GOODWILL INDUSTRIES ADDITION
TO WICHITA, SEDGWICK COUNTY, KANSAS

Re: S/D 93-66 - GOODWILL INDUSTRIES ADDITION Final Plat

STAFF REPORT
(Final Plat Approved 11/10/93)

CASE NUMBER: S/D 93-66 GOODWILL INDUSTRIES ADDITION

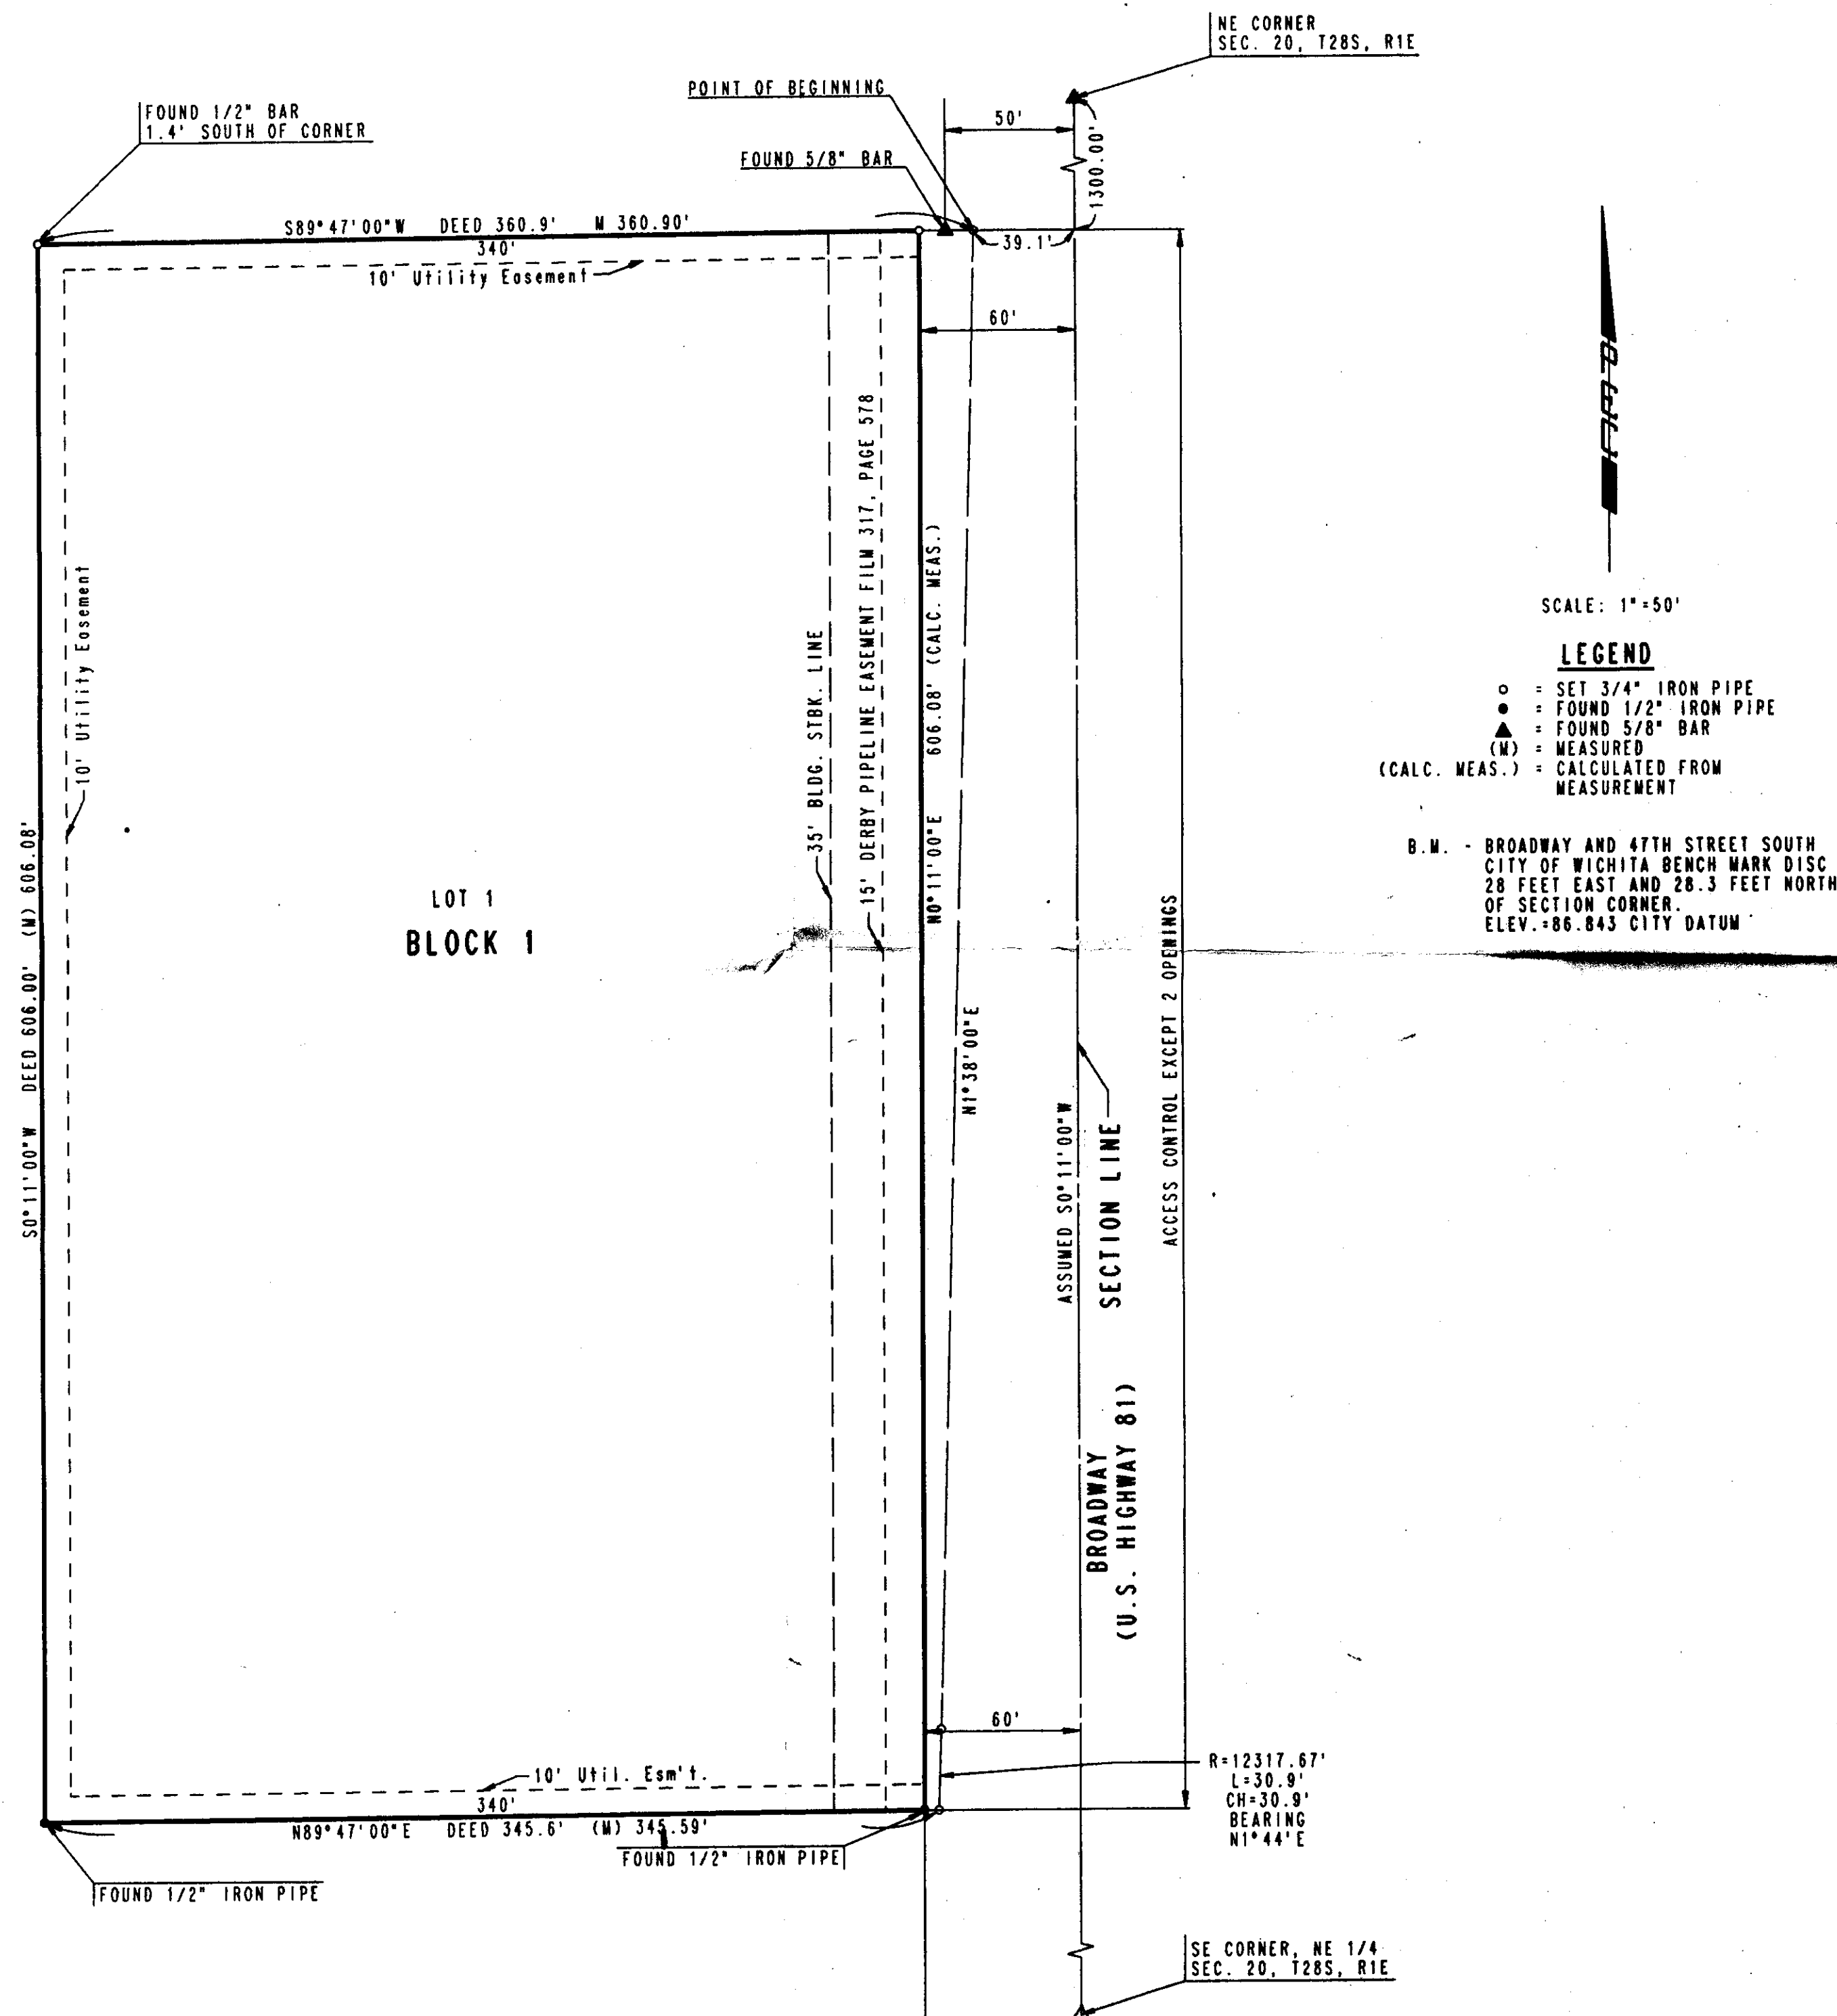
- C. The applicant is advised that a copy of this plat is being submitted to the Kansas Department of Transportation (KDOT) for their review of the indicated access control. If any changes in the indicated access control are required by KDOT, the final plat tracing shall indicate this.

- D. The applicant shall submit a copy of the instrument which establishes the Derby Pipeline Easement on this property. The applicant's agent shall determine any setback requirements from the pipeline by researching the text of the pipeline agreement. If a setback from the pipeline easement is provided for in the pipeline easement agreement, it shall be indicated on the face of the plat.

- G. The applicant's engineer is advised that the Register of Deeds is requiring the name(s) of the notary public, who acknowledges the signatures on this plat, to be printed beneath the notary's signature.

- H. Perimeter closure computations shall be submitted with the final plat tracing. Section 5-101(c).
- I. Recording of the plat within 30 days after approval by the City Council.
